CS Memorandum No. 1444

Subject: Configuration Management Board Meeting No. 125

CMB Meeting Minutes #125

SUBJECT: Configuration Management Board Meeting # 125 – Rev. No. 0

SFMTA Central Subway Project
 Contract CN1252
 Figure 2A - Additional Instrumentation Layout

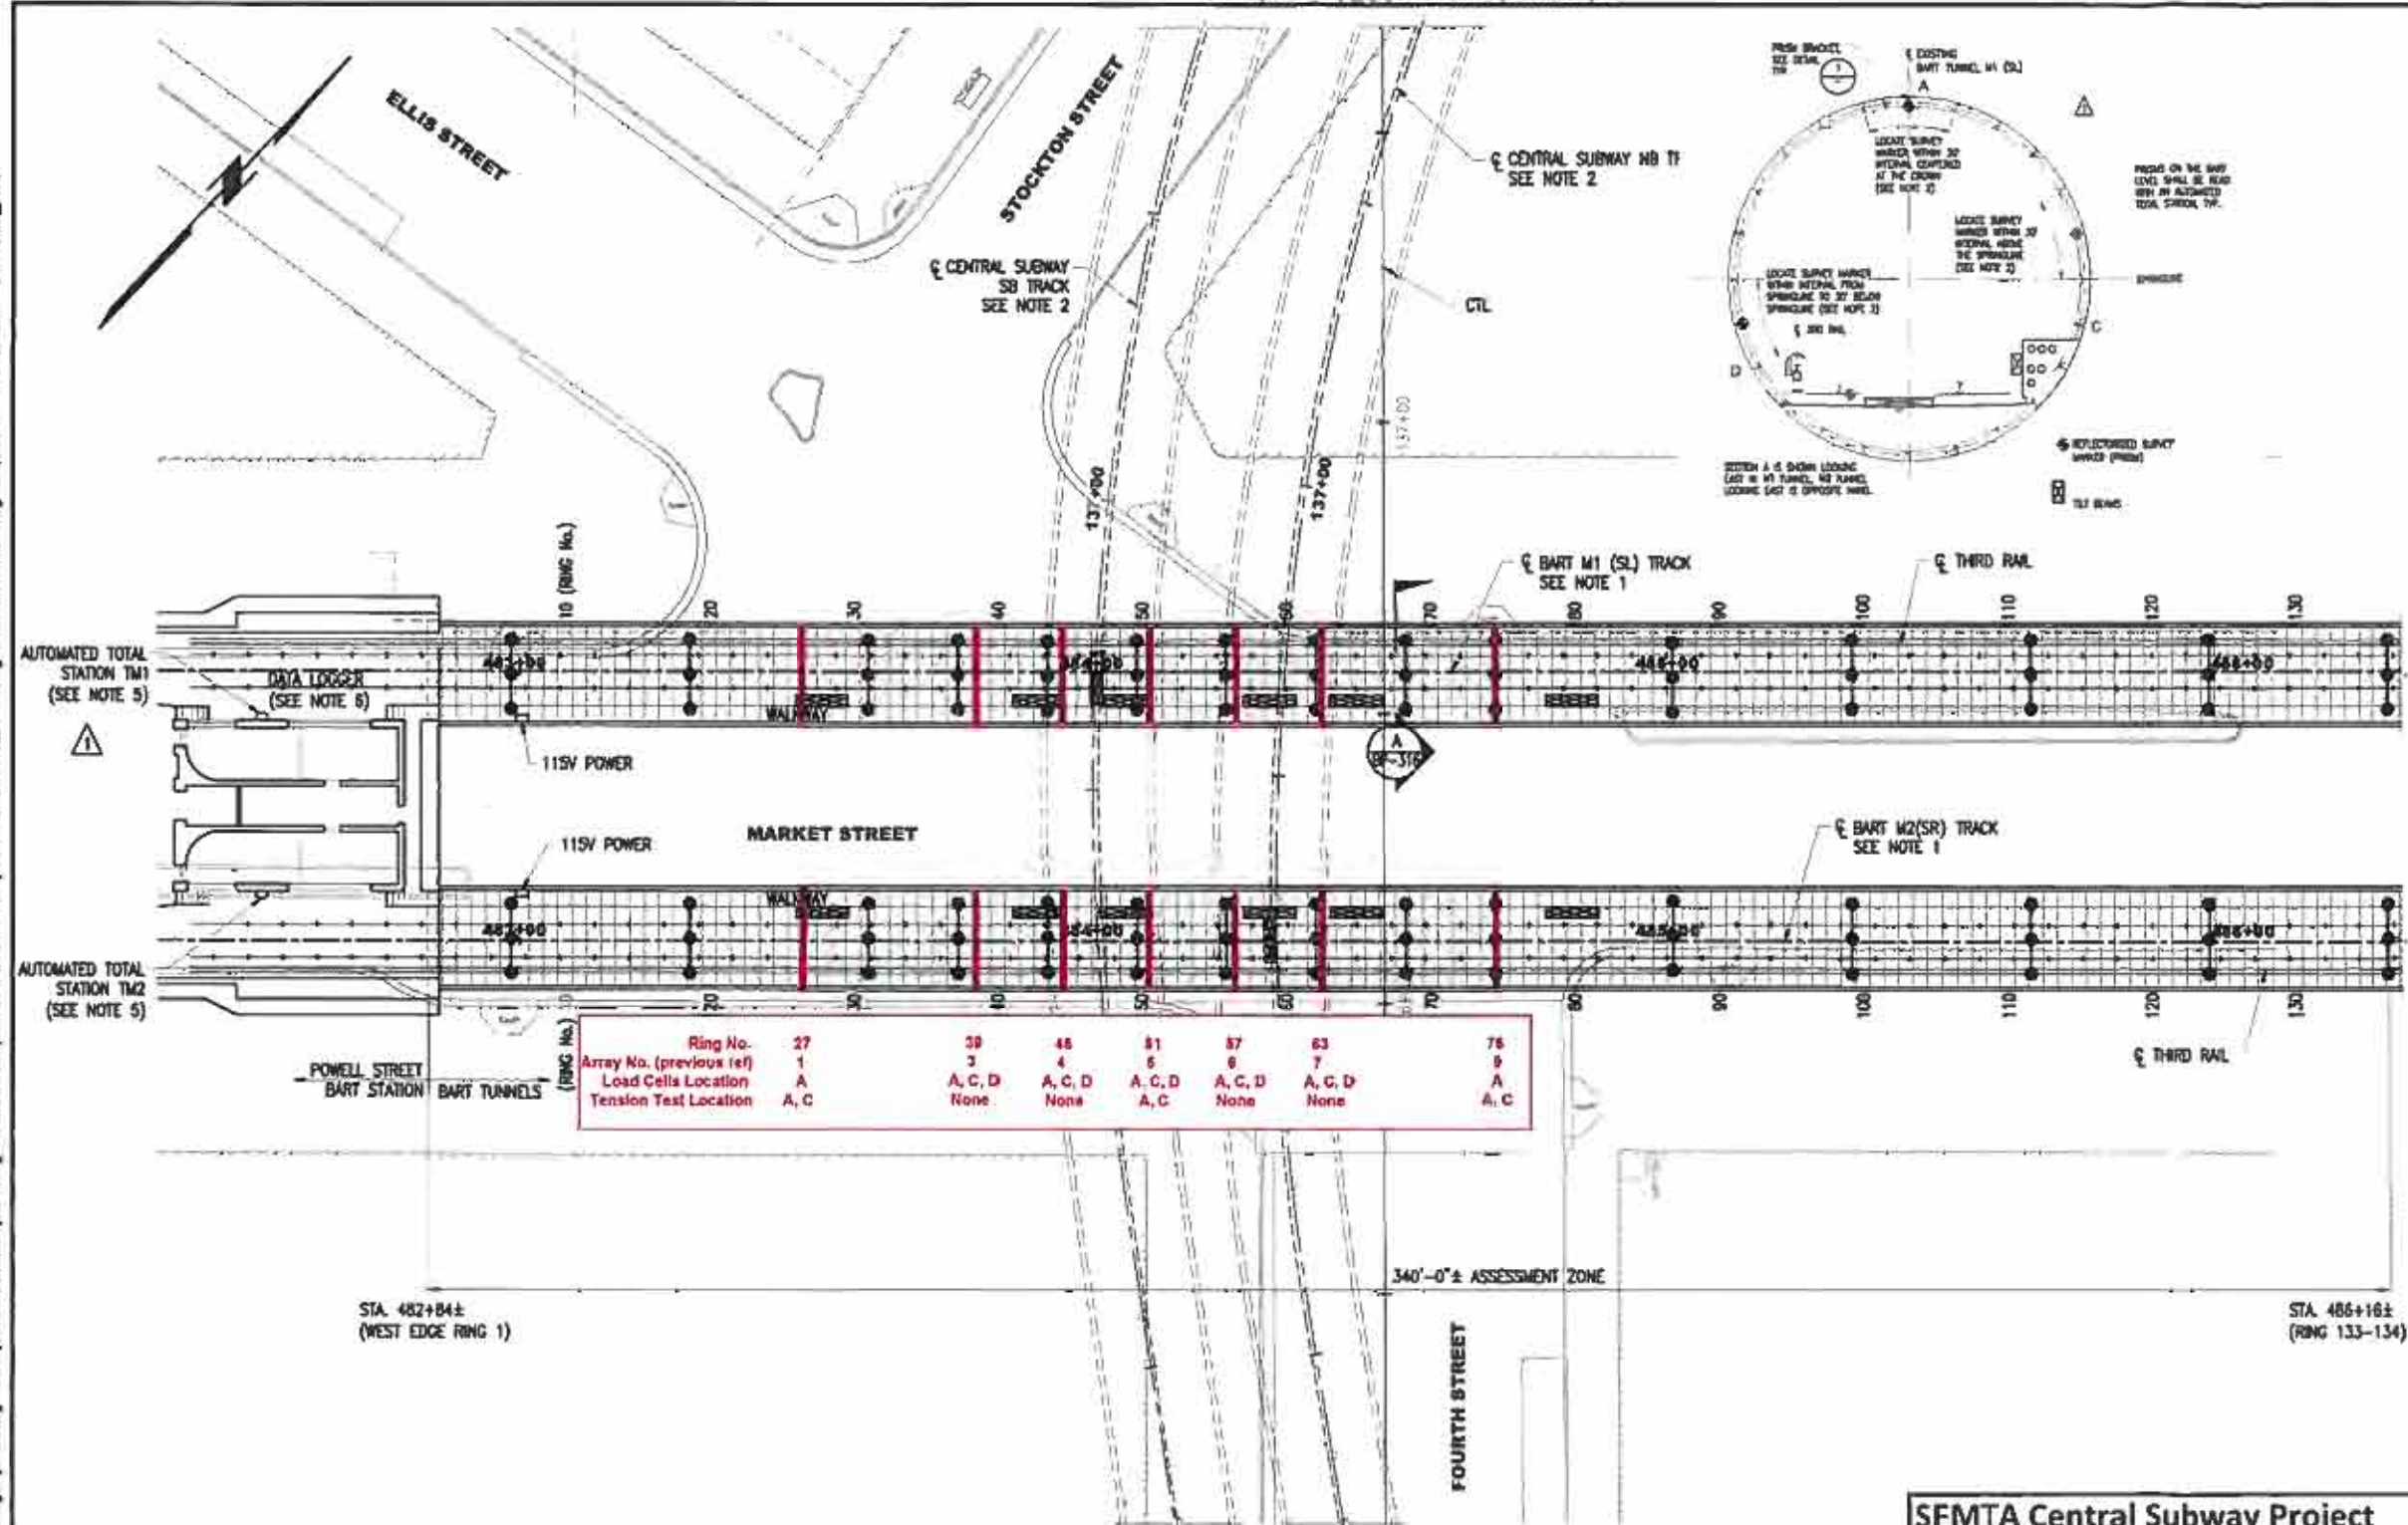
1. Implement additional instrumentation of BART tunnel lining:
 - A. Existing bolt preload force – Determine the actual load in 6 bolts identified as "Tension Test Location" in Figure 2A in each tunnel (M1 and M2) for a total of 12 bolts. If the bolt is replaced with a new bolt that will be used for monitoring bolt force, the bolts removed for testing shall be replaced with the longer bolt and load washer configuration shown in Figure 3.

The method of measurement shall be as demonstrated in report by Marvin Manufacturing.
 - B. Bolt force sensor – Install 17 bolt force sensors at bolts identified as "Load Cell Location" in Figure 2A in each tunnel (M1 and M2) for a total of 34 bolts. Bolt force sensors shall be added using new A325 bolts, nuts, flat washers. (See Figures 3 and 4 for layout of instrumented bolt and sensor data.) Bolt force sensors shall remain and not be later removed. Wiring from sensors to datalogger shall be affixed securely to tunnel and removed at completion of tunneling for Contract No. 1252 to the limits requested by BART. Monitor the forces in bolts per contract requirements.

SFMTA Central Subway Project
 Contract CN1252
 Figure 3 — Instrumented Bolt Layout

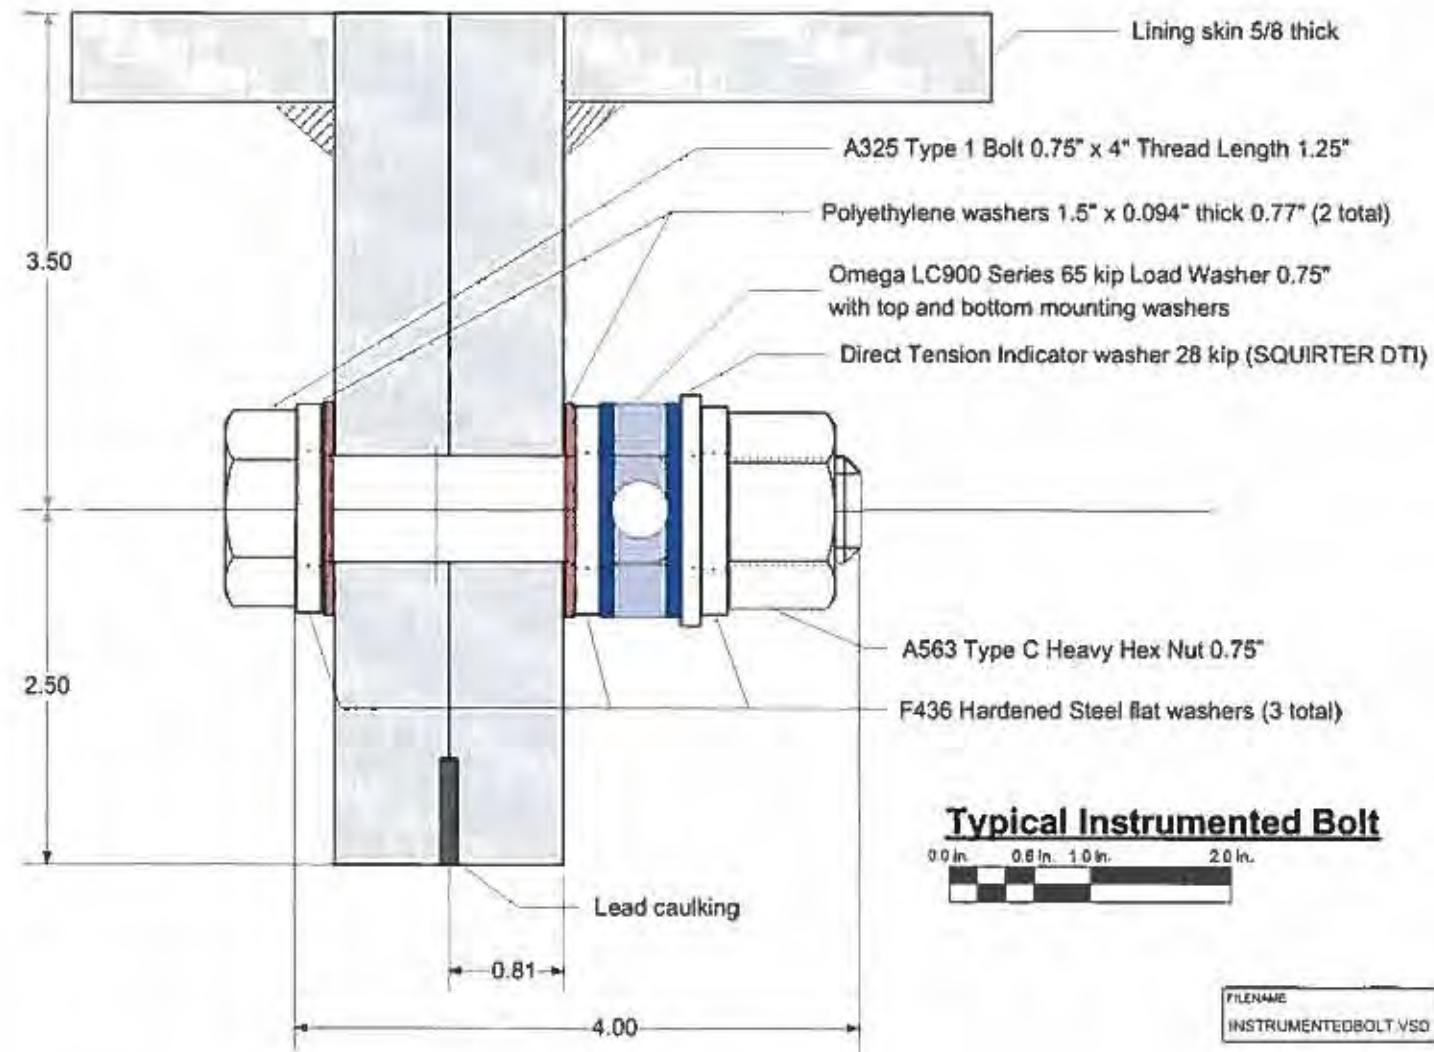
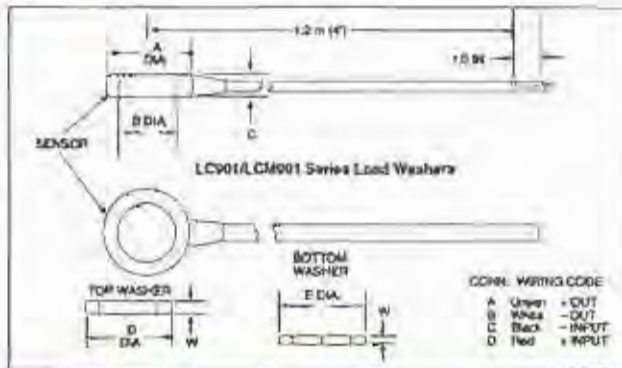
- A) Existing bolt preload force – Determine the preload forces in 12 bolts. The selected bolts removed for testing shall be replaced with the longer bolt and load washer configuration shown in Figure 3.

- B) Bolt load cell – Install 17 additional load washers on bolts identified in Figure 2 in each tunnel (M1 and M2 for a total of 34 bolts. Load washers shall be added using new A325 bolts, nuts, flat washers. (See Figures 3 and 4 for layout of instrumented bolt and sensor data.) Bolt load washers shall remain and not be later removed. Wiring from load washers to datalogger shall be affixed securely to tunnel and removed at completion of tunneling for Contract No. 1252 to the limits requested by BART. Monitor the forces in bolts per contract requirements.

"OLD NAVY"
COMP GROUT TRENCH
AS-BID

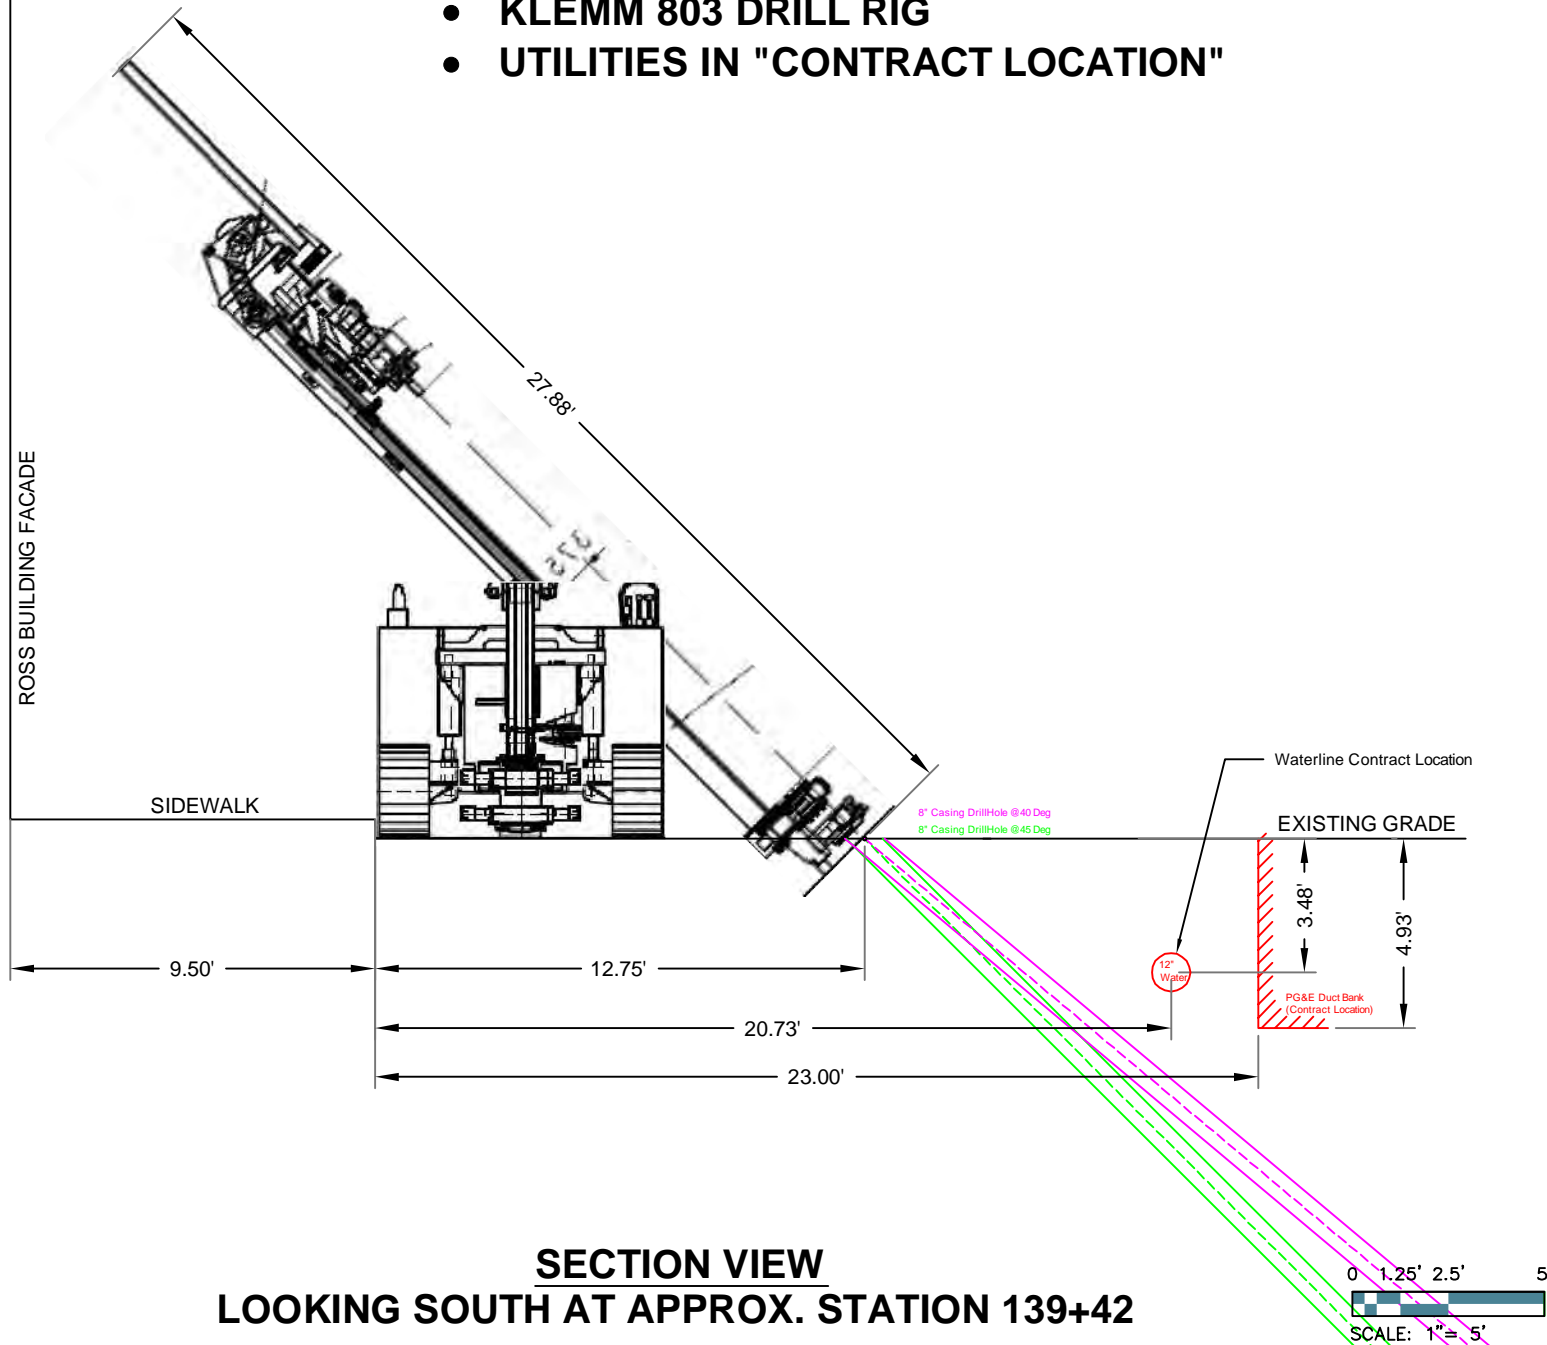
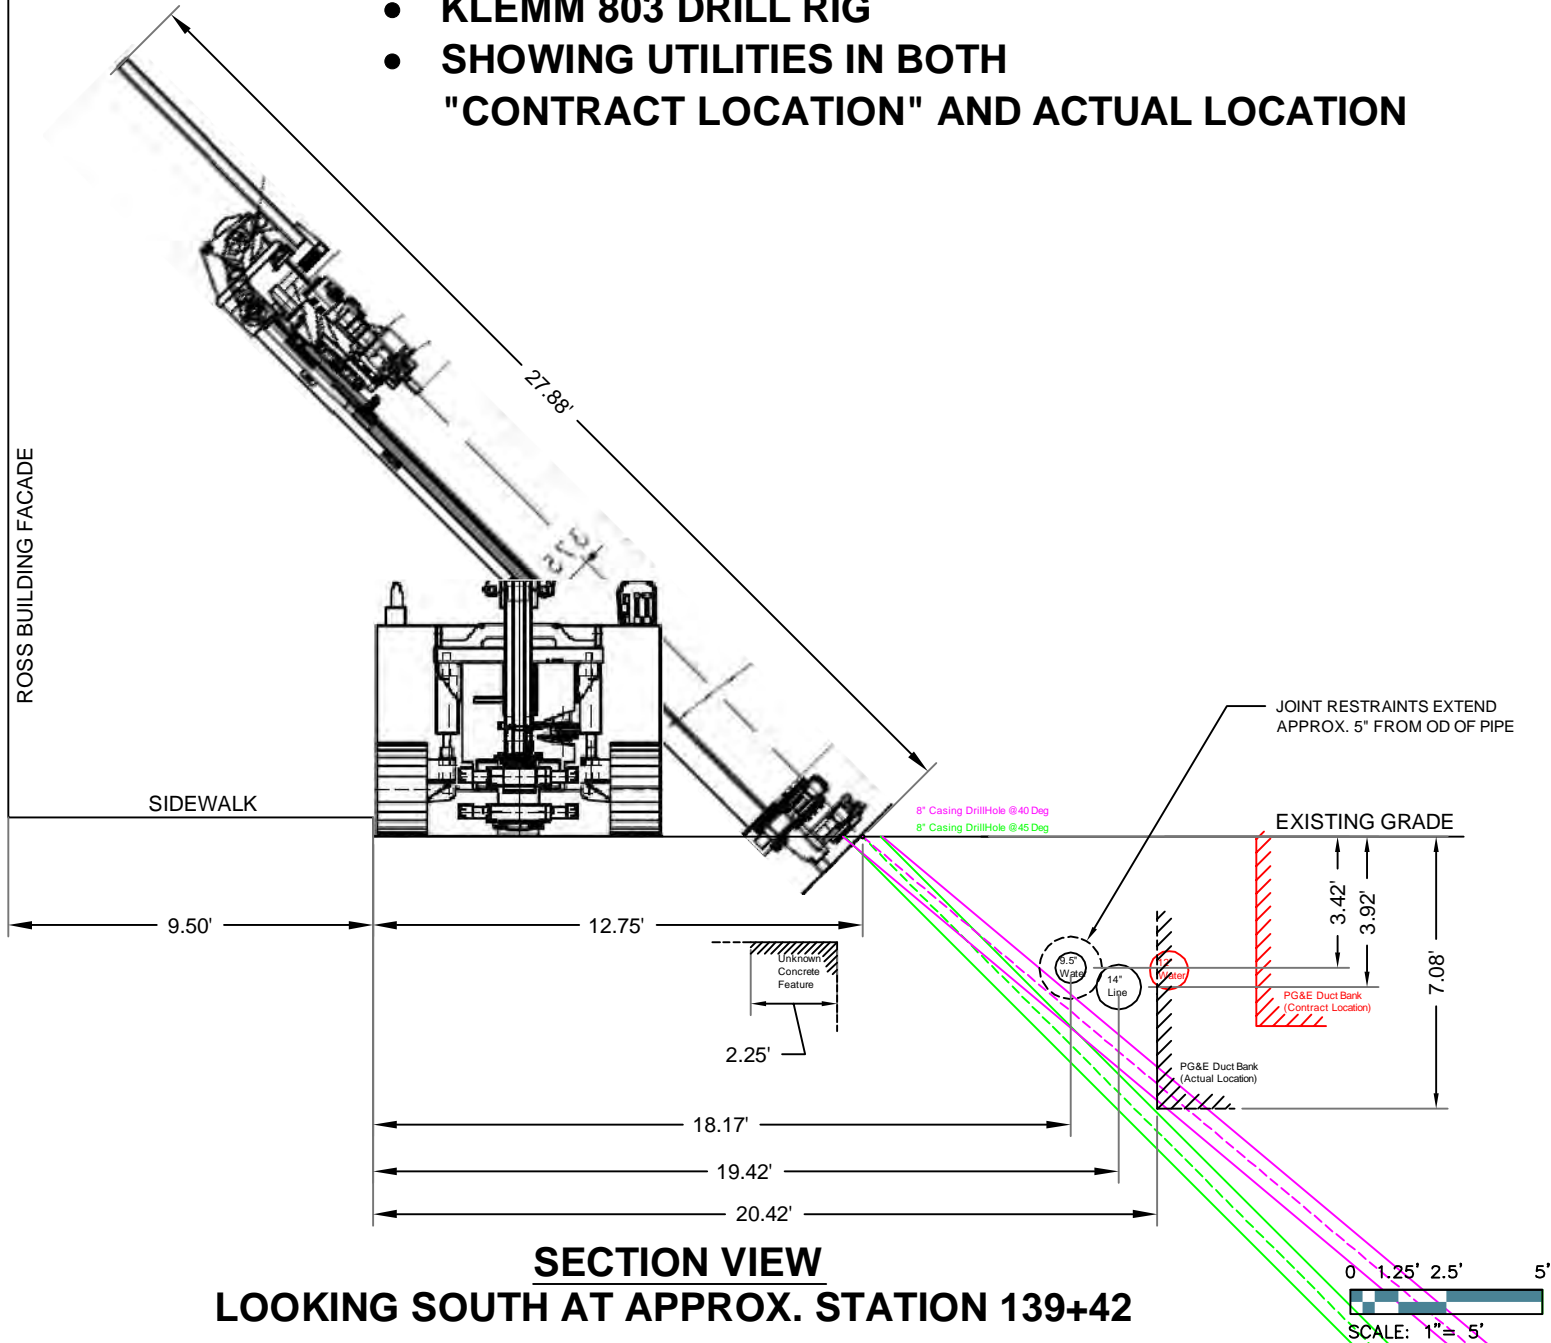
After further field investigation with PG&E and additional potholing efforts, it was determined that there was not sufficient room between existing utilities (known and unknown) to drill the compensation grout holes as designed. The Contractor was able to remove many of these obstructions in an effort to identify a clear window of space in which to locate the proximal points of the compensation grout pipe array. However, one of the obstructions consisted of what was originally believed to be a live 12" waterline which would have caused the proximal points to shift to the east to avoid the live utility. On 4/4/13, it was discovered that this utility was not actually the 12" live waterline and on 4/5/13, PG&E confirmed that the utility was actually a 12" abandoned gas line.

- Sketches 045 through 047. However, the Contract Documents, specifically the Utility Demolition and Utility Composite drawings, do not show whether the 12" gas line is live or needs to be removed.
4. The PGE electrical duct bank was deeper and further east than originally anticipated.
 5. The waterline shown on the drawings was further east than shown on the Contract drawings. See Field Sketches 045 through 046.
 6. A sub-sidewalk basement within the Ross Dress for Less building was discovered to have an unknown roof load capacity. This resulted in the need to bring in a smaller drill rig that could install the compensation grout tubes from the roadway and avoid installation on top of the basement.
